ADDENDUM
PURCHASING OFFICE
CITY OF AUSTIN, TEXAS

REQUEST FOR PROPOSAL NO: **OPJ0114** ADDENDUM NO. **3**. DATE OF ADDENDUM: **MARCH 18, 2015**

ADDENDUM THREE

PROJECT: Chiller #10 Installation Project /Domain District Cooling Plant

SHEET NO. M2.0

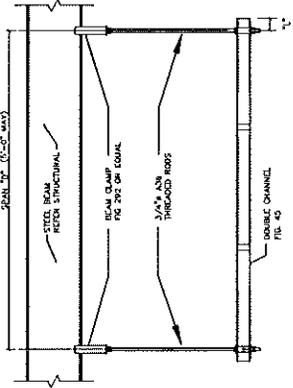
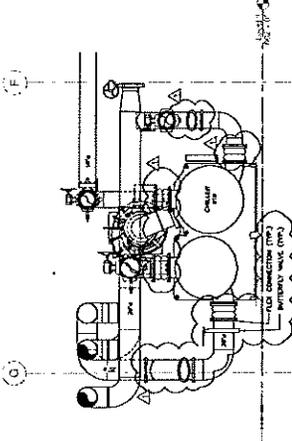
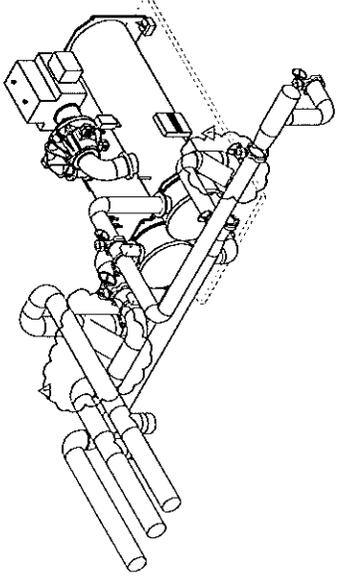
Question: Please provide detail on the piping supports with channel sizing as per structural member and max load requirements on sheet M2.0.

Guerra Response - Support spacing was engineered to accommodate pipe loads at the structure. Channel sizes are scheduled on Anvil International Fig. #45 which is reference on Detail 5/M2.0
